FRESNO METROPOLITAN FLOOD CONTROL DISTRICT

April 27, 2012

- Subjects: 1) Verification of existing facilities within project limits**
- 2) Establishing District Occupancy Rights to the location**

The District has completed the review of the Contract Packages 1A, 1B and 1C provided by Tony Valdez in PDF formatting on April 18, 2012 and have the following comments to offer.

Drawing NO. CV-G1013

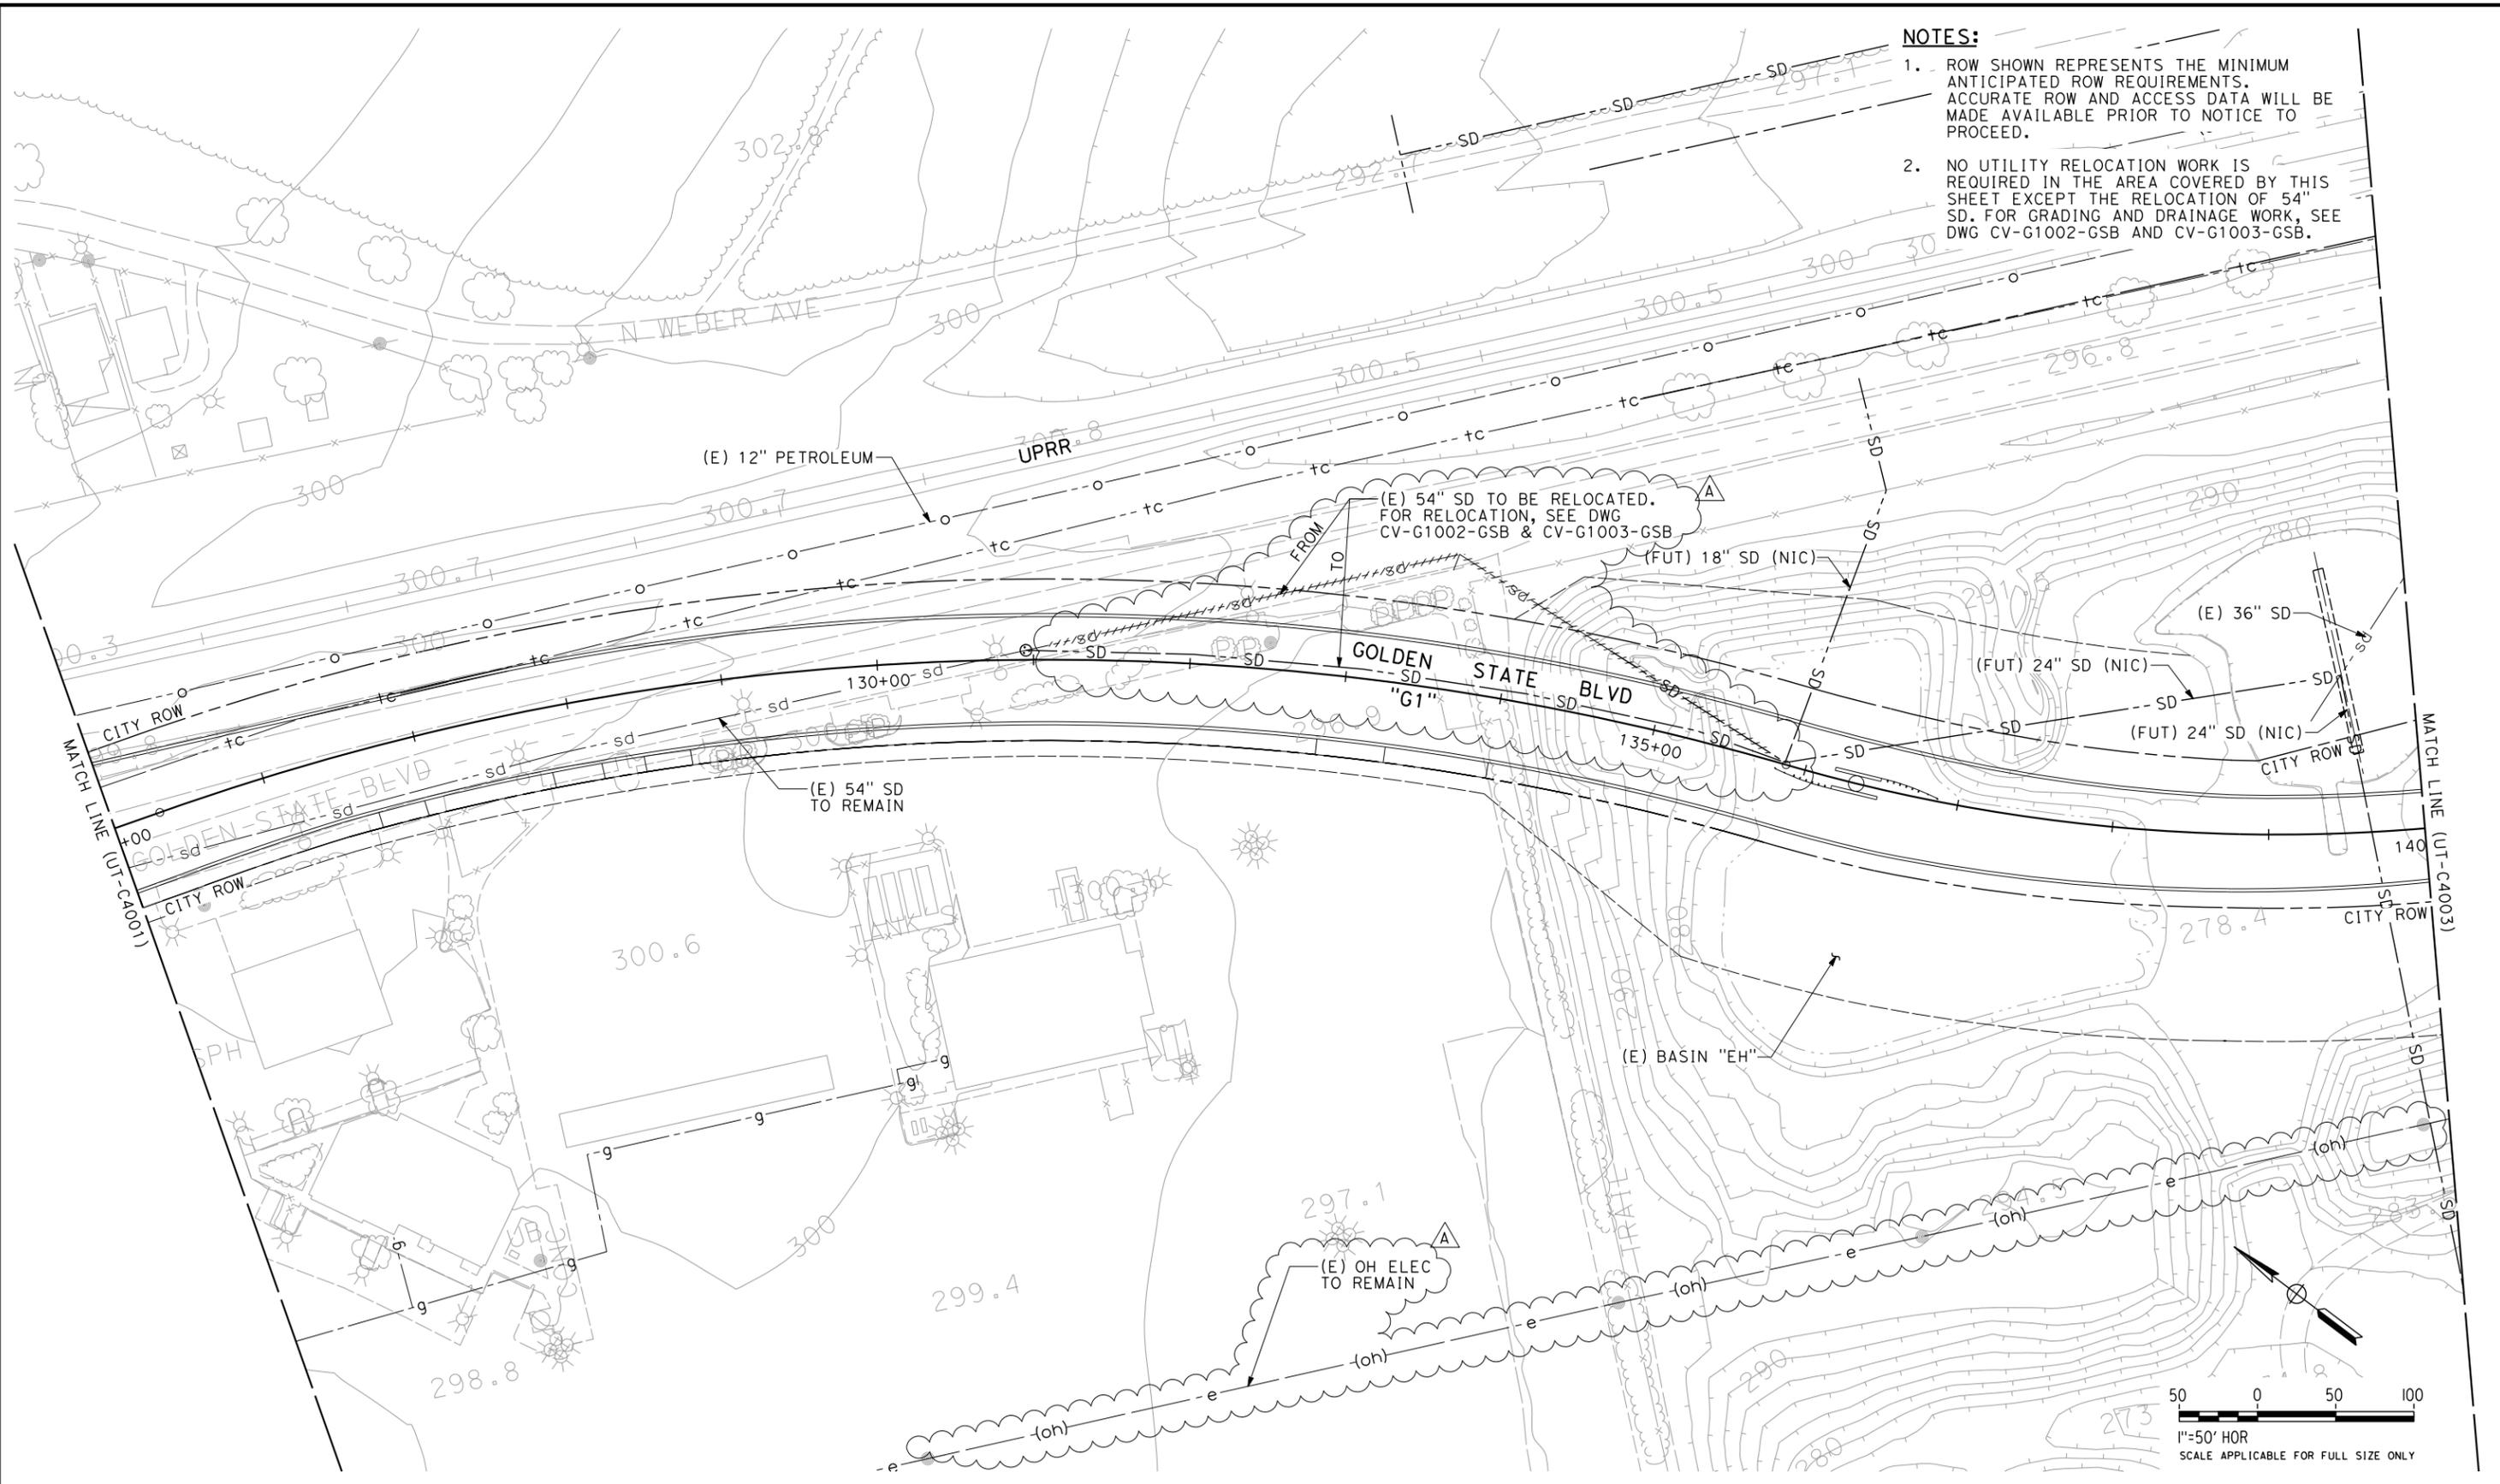
13) 96-inch diameter Storm drain (approx. Sta. S10913+00) located in existing Basin Property COPY E1 and E2 attached, and Union Pacific Railroad Company agreement COPY F attached (Lease Audit Number 221470) ← To be addressed by RC of F-B Segment

CONTRACT NO.
DRAWING NO.
UT-C4002
SCALE
AS SHOWN
SHEET NO.

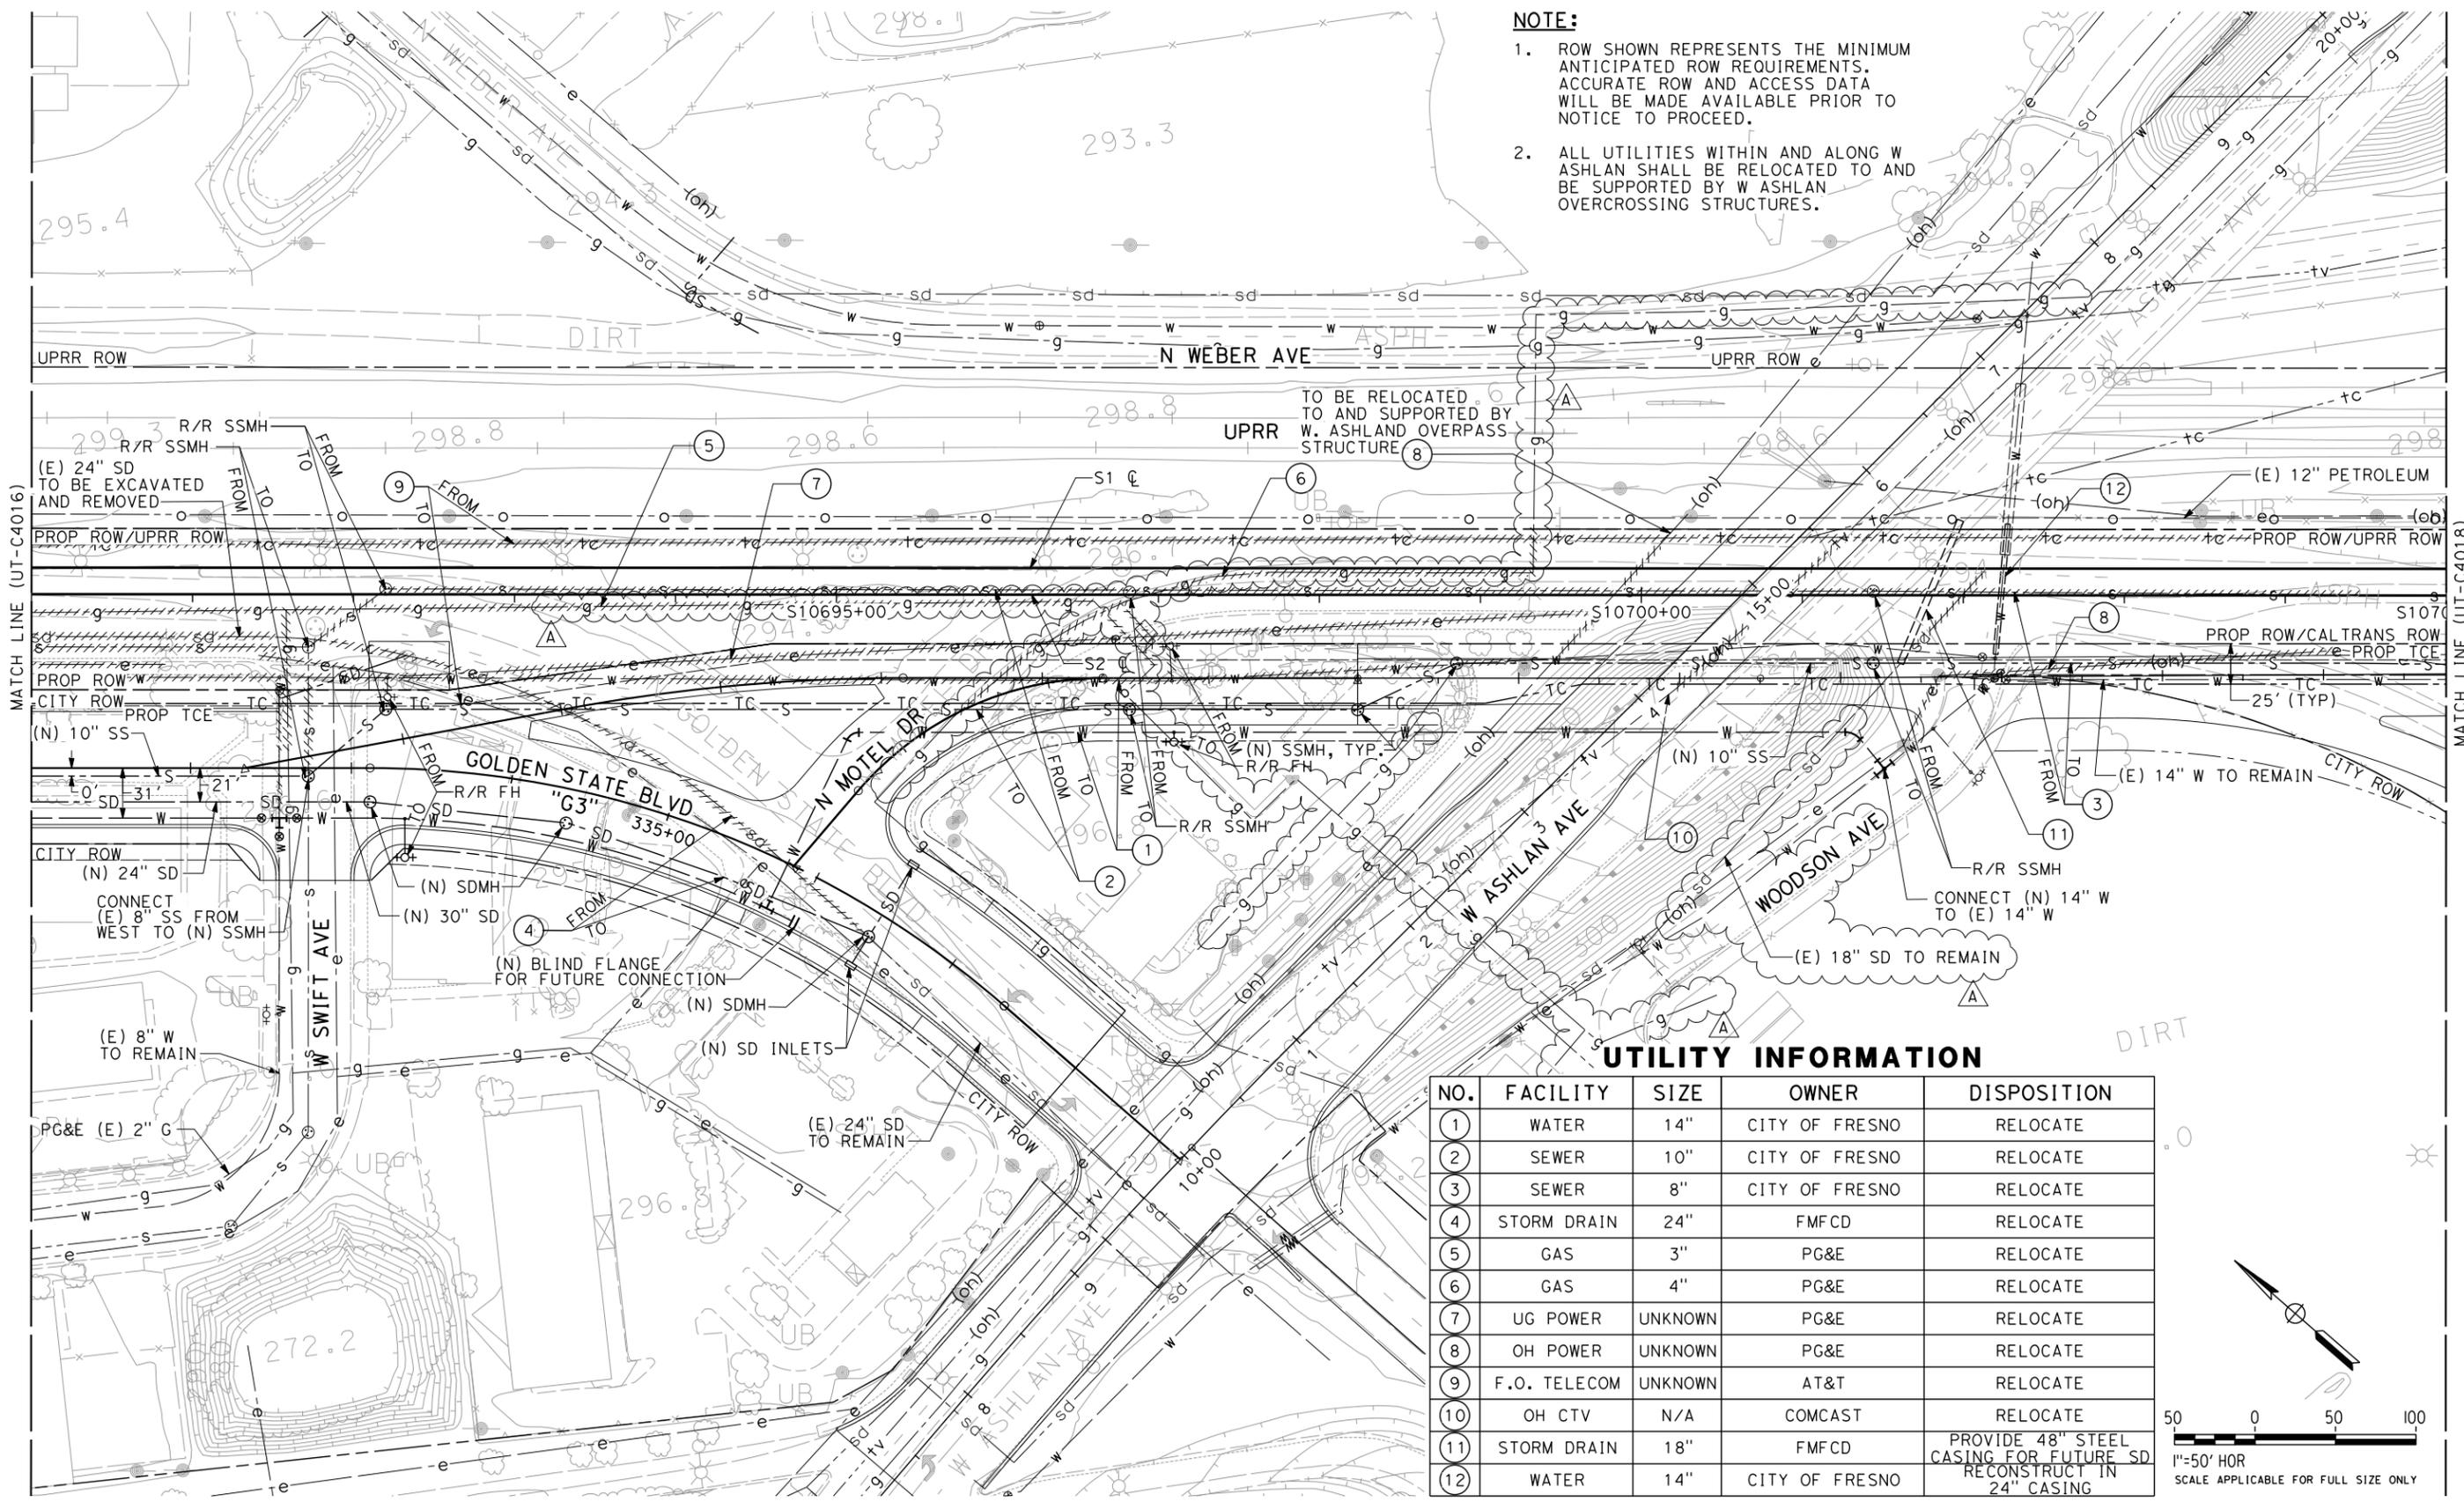
3) Basin "EH" Grant Deed COPY B1 and B2 attached (Doc No. 94147277) and 54-inch diameter Storm drain located in existing Street Right of Way (Golden State)

4) 36-inch diameter Storm drain (approx. Sta.141+00) located within the existing Street Right of Way and Basin "EH" (Golden State)

This is the typo of UT-C4002

Concur. The 54" SD is within the Street R/W, and we now show on the revised plan that this 54" SD will be relocated to within the new GSB R/W.

Concur. The 36" SD is within the Street R/W.

CONTRACT NO.
DRAWING NO. UT-C4017
SCALE AS SHOWN
SHEET NO.

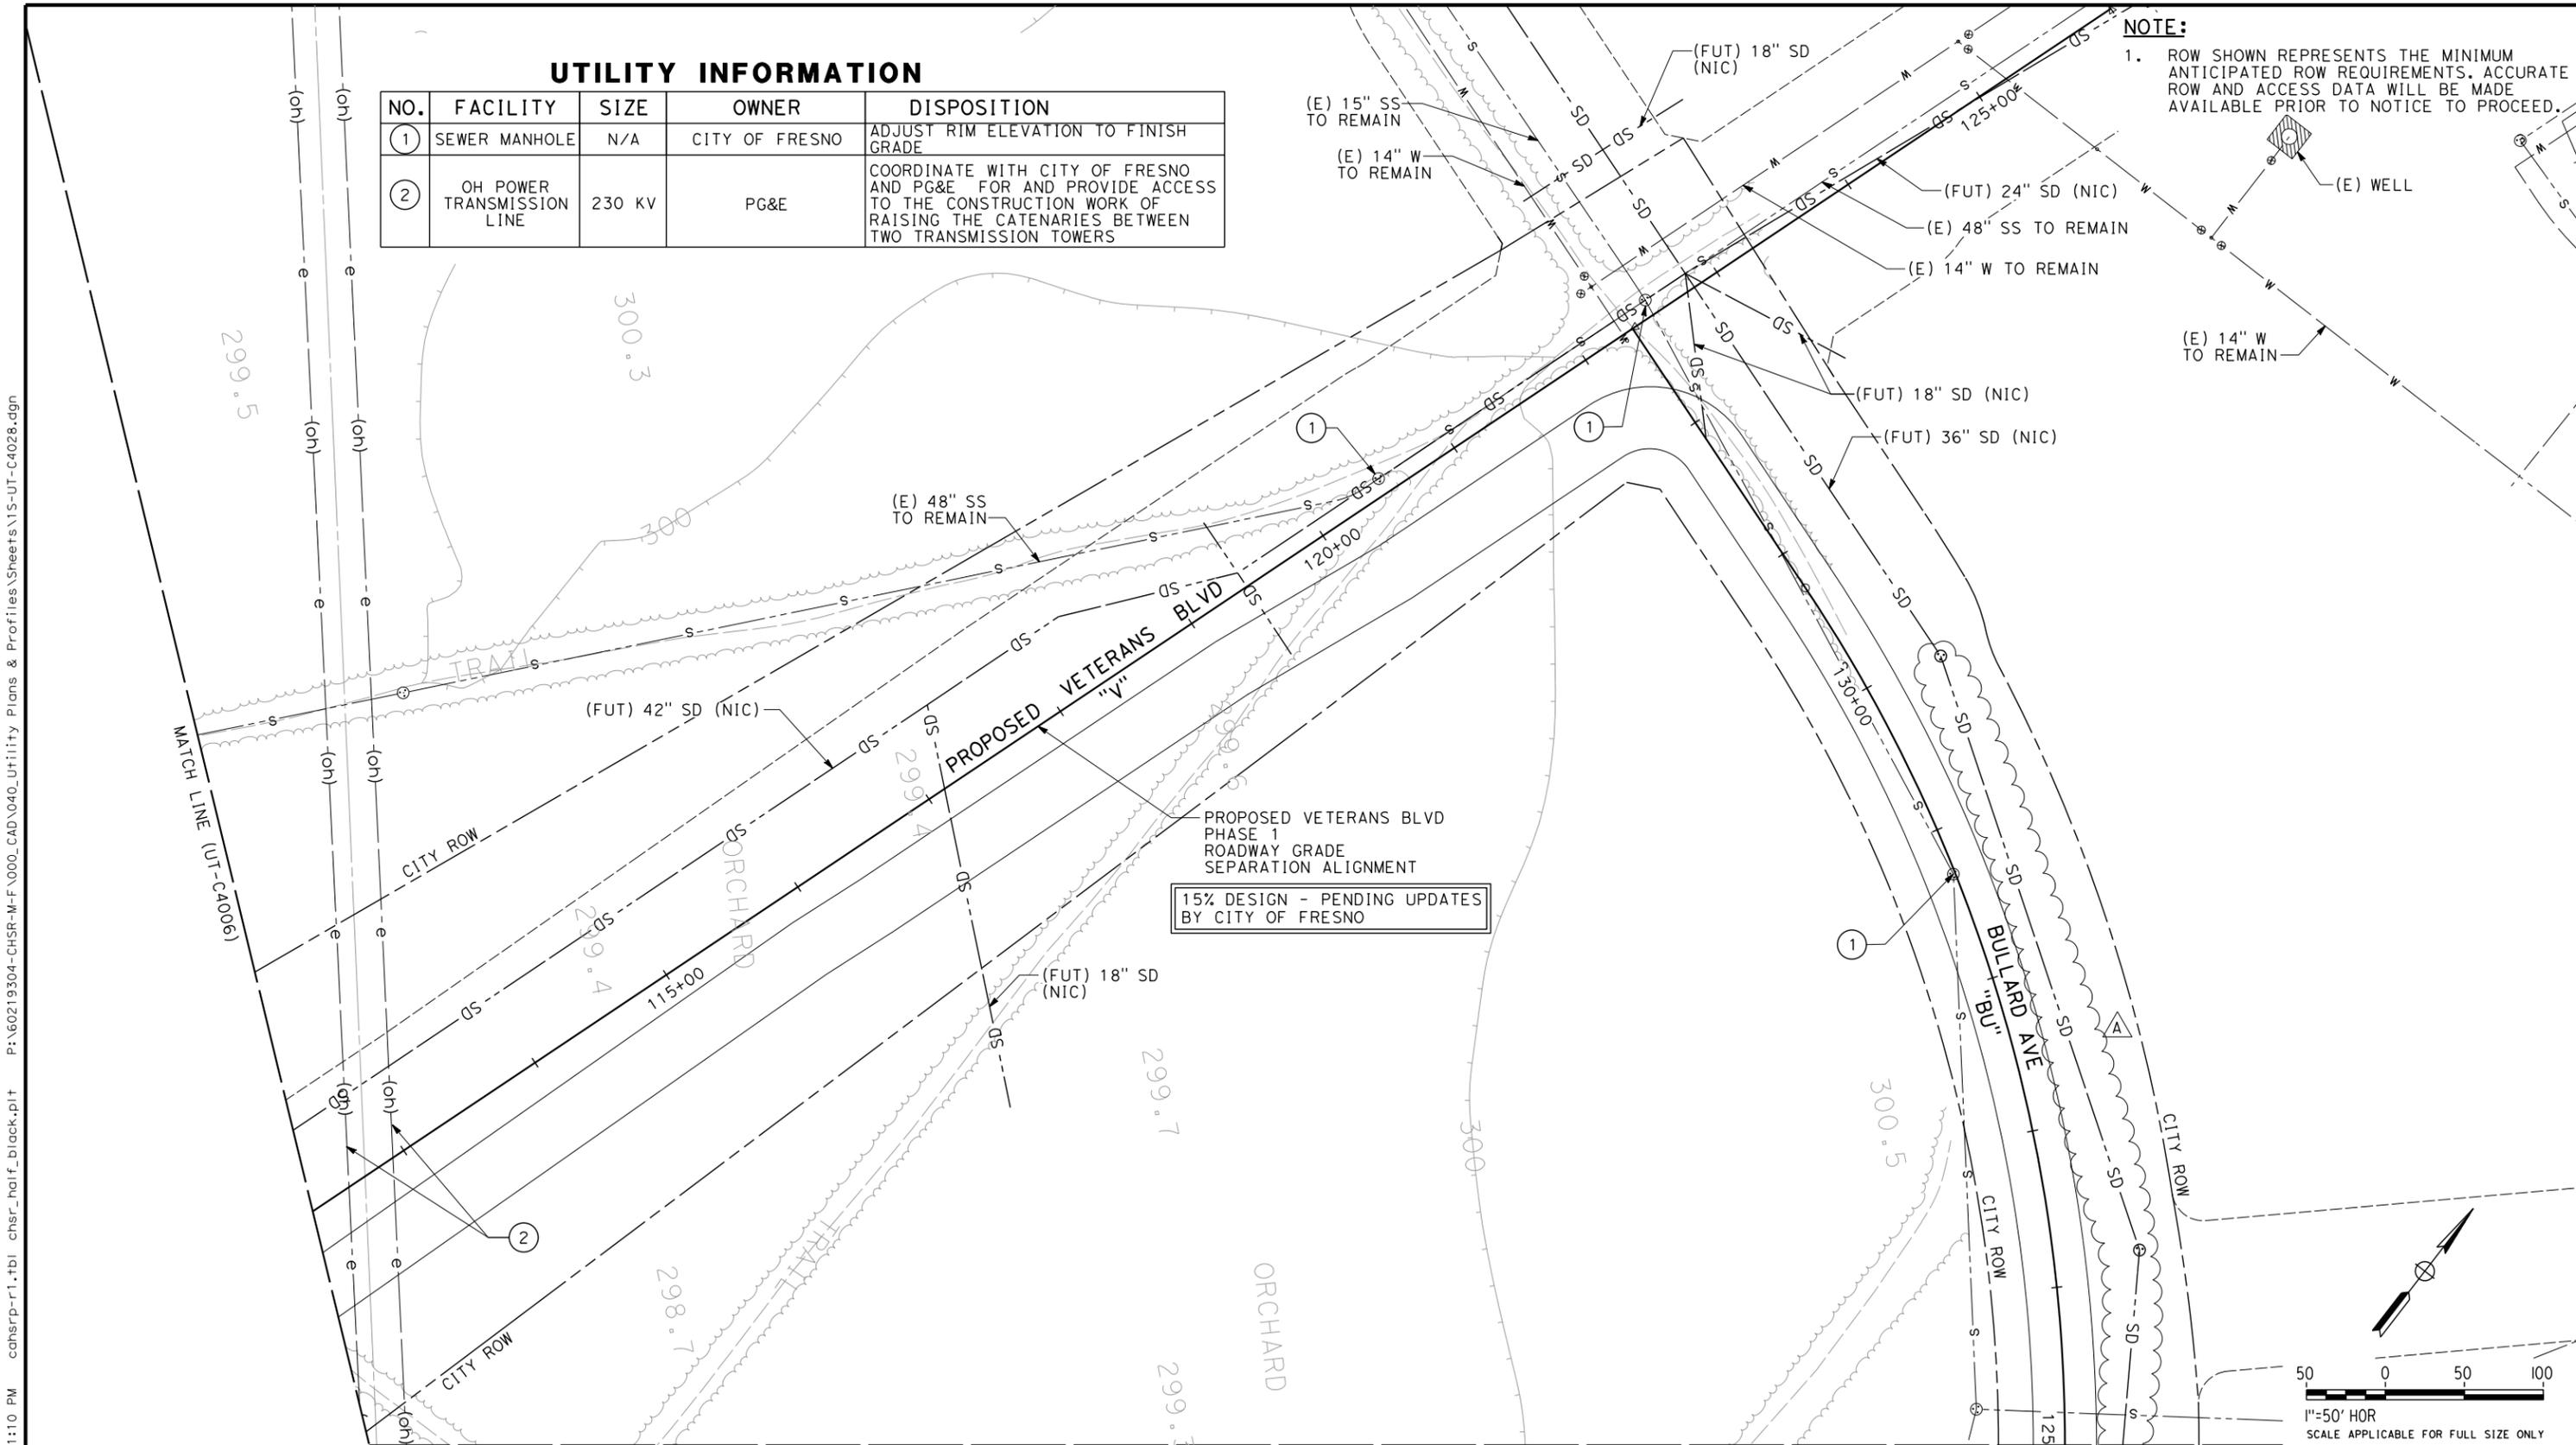
- 16) - Utilities, Composite Utility Plan, Drawing NO. UT-C4017, the existing 18-inch diameter pipe is located within the street right of way in Woodson Avenue not as (FUT) 18-inch SD (NIC) in the side slope of fill for Ashlan Avenue as shown.

Concur. See revised drawing attached.
